Access Compliance Report

Public Rights-of-Way

(Curb Ramps)

Intersection ID: 10041619	Main Street: WHITEHALL COMMONS CENTER DR	Cross Street: N/A	Location: SW
ADA ID: 8D50149CF693	Ramp Type: PerpDiag	Initial Pass/Fail: Fail	Overall Compliance: No
Severity Score: 35			
Codes/Mitigation Info/Possible Solution		Field Measurements/Component Compliance

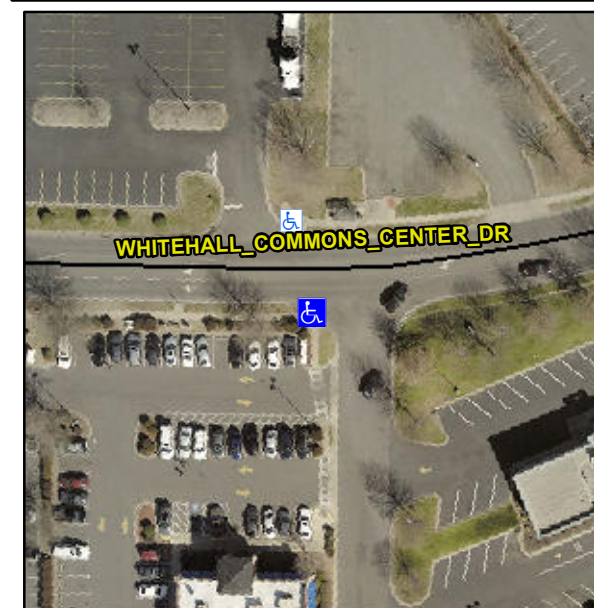
R304.5.1, R304.2.2, R304.5.3

Compliance	Description	Data	Compliance	Description	Data
N/A	Ramp Length (in)	90.0	No	Ramp Slope (%)	12.1
No	Ramp Width (in)	40.0	No	Ramp XSlope (%)	2.1
N/A	Flare Type LT	N/A	N/A	Flare Type RT	N/A
N/A	Flare Slope LT (%)	N/A	N/A	Flare Slope RT (%)	N/A
N/A	Flare Traversable LT?	N/A	N/A	Flare Traversable RT?	N/A
N/A	Landing Length (in)	N/A	N/A	DWS Provided?	N/A
N/A	Landing Width (in)	N/A	N/A	DWS Contrast?	N/A
N/A	Landing Slope (%)	N/A	N/A	DWS Length (in)	N/A
N/A	Landing X Slope (%)	N/A	N/A	DWS Full Width?	N/A
N/A	Landing Curb? (Y/N)	N/A	N/A	DWS Offset (in)	N/A
N/A	Shared Landing?	N/A			
N/A	Gutter Ponding?	N/A	N/A	Gutter Slope (%)	N/A
N/A	Gutter Lip Ht (in)	N/A	N/A	Gutter X Slope (%)	N/A
N/A	Painted X Walk1?	No	N/A	Painted X Walk2?	No
	X Walk 1 Direction	To E		X Walk 2 Direction	To N
N/A	X Walk 1 Width (in)	N/A	N/A	X Walk 2 Width (in)	N/A
	X Walk 1 Slope (%)	0.9		X Walk 2 Slope (%)	0.9
	X Walk 1 X Slope (%)	0.9		X Walk 2 X Slope (%)	1.5

Remove & Replace Curb Ramp With Two New Directional Ramps or Equivalent.
